Citroen Jumper II With 2.8 HDI engine From serial number 17443608 to 17545710

Vehicle starts poorly

Bulletin

Fig. 1

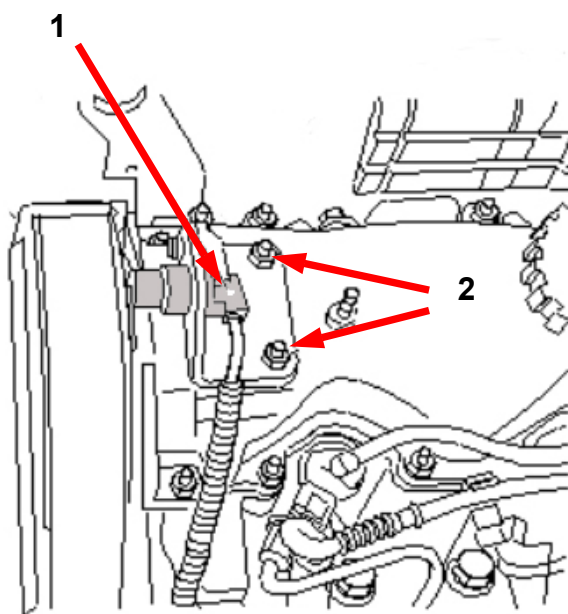
If there are complaints about the above-mentioned fault, the cause could be incorrect positioning of the camshaft sensor. This leads to the engine starting poorly. Due to incorrect geometry of the retaining clamp for the camshaft sensor, the distance between sensor and camshaft pulley is too great. In this case, the position of the sensor must be corrected with the aid of two washers. These washers, with a very particular "thickness", can be obtained via the manufacturer.

- Disconnect the battery.
- Remove the engine cover.
- Remove the plug (see Fig. 1, Item 1) from the sensor.
- Unscrew the fastening nuts from the holder (see Fig. 1, Item 2) and remove the holder upwards.
- Fit a washer to both stud bolts.
- Refit the sensor holder. Initially however, tighten the fastening nuts only lightly, so that the holder can still be moved.
- Now line up the holder such that the distance between the sensor and the reference mark on the camshaft pulley is 0.8–1.5 mm (see Fig. 2).
- Tighten the fastening nuts.
- Refit removed parts in reverse order.
